MEMORANDUM
May 7th, 2014

TO: Landmarks Board

SUBJECT: Public hearing and consideration of an application for a Landmark Alteration Certificate to construct a new two-car, 950 sq. ft. detached garage with an Owners Accessory Unit above at 420 Spruce St. in the Mapleton Hill Historic District, per section 9-11-18 of the Boulder Revised Code (HIS2014-00081). Applicant: Juana Gomez Owner: Luis and Julia Garza.

Figure 6. Proposed site plan.

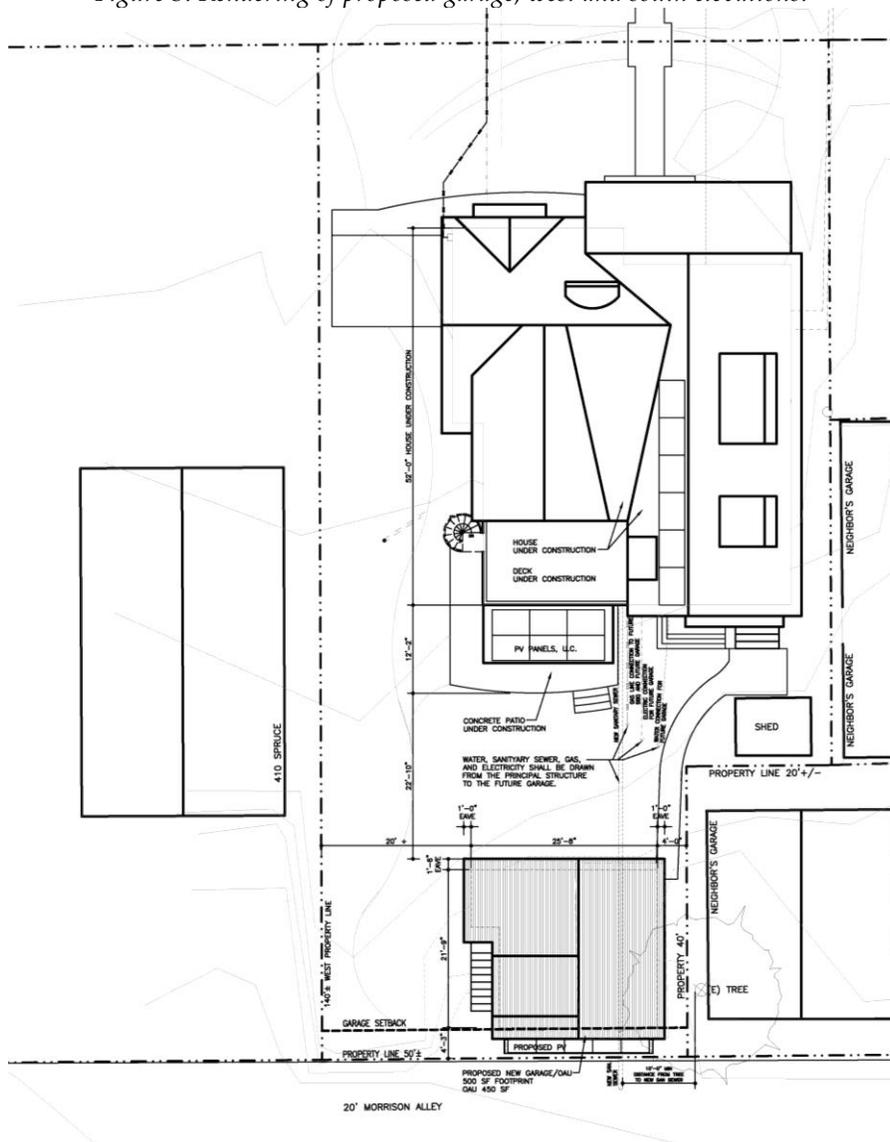
In plan, the proposed garage measures approximately 21'9 by 21'9 and is shown to be located at the southeast corner of the lot, with alley access to the south. A rear deck, approved under a separate Landmark Alteration Certificate, is to be located at the rear of the primary house. Approximately 22' of landscaped area would separate the proposed garage and rear deck on the house.

Figure 7. Proposed south elevation

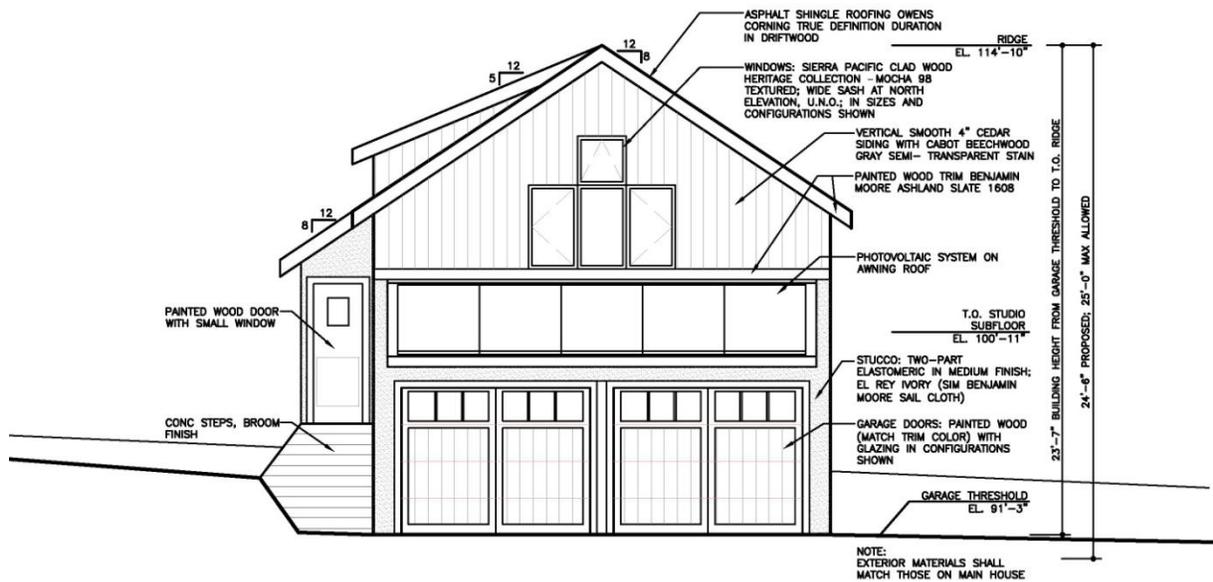
<i>in terms of size and massing.</i>	terms of proportion and style, however, the 24'6 height is much greater than the typical height of accessory buildings in the historic district. Consider lowering 3–5' in height to 1 & ½ story building and reduction of mass and scale of garage to be more in keeping with historic accessory buildings in Mapleton Hill.	
.6	<i>New garages for single-family residences should generally be one story tall and shelter no more than two cars. In some cases, a two-car garage may be inappropriate.</i>	Proposed two-car garage measures 24'6 in height and is two-stories tall. The property is located at the southwest corner of the historic district, and is in the RMX-1 zoning district. This portion of the alley has an eclectic mix of building types and sizes, and is bordered on the south by a 1990s condominium building. Staff considers that a two car garage in this location will not detract from the character of the historic district. However, the building should be reduced in height to be more in character with accessory buildings within the historic district. Resolve at Ldrc.	Maybe

shown on south (alley-facing) elevation relates to the non-contributing house but is unusual in the historic district. A simplified window pattern may be more appropriate. Resolve at Ldrc.	
.11	<i>If consistent with the architectural style and appropriately sized and located, dormers may be an appropriate way to increase storage space in garages.</i>	Shed dormer on west elevation shown to be appropriately sized and located, and subordinate to the main roof form.	Yes
.12	<i>Garage doors should be consistent with the historic scale and materials of traditional accessory structures. Wood is the most appropriate material and two smaller doors may be more appropriate than one large door.</i>	Garage doors proposed to be painted wood; appear to be consistent in terms of scale and materials. Review final details at Ldrc.	Yes
.13	<i>It is inappropriate to introduce features or details to a garage or an accessory building in an attempt to create a false historical appearance.</i>	Proposed design does not attempt to recreate a false historic appearance.	Yes

2. Prior building permit application and final issuance of the Landmark Alteration Certificate, the applicant shall submit revised plans for the proposed garage showing a reduction in height of the building so that it reads as a one-and-one half story building consistent with the *General Design Guidelines for Boulder's Historic Districts and Individual Landmarks* and the *Mapleton Hill Design Guidelines*.
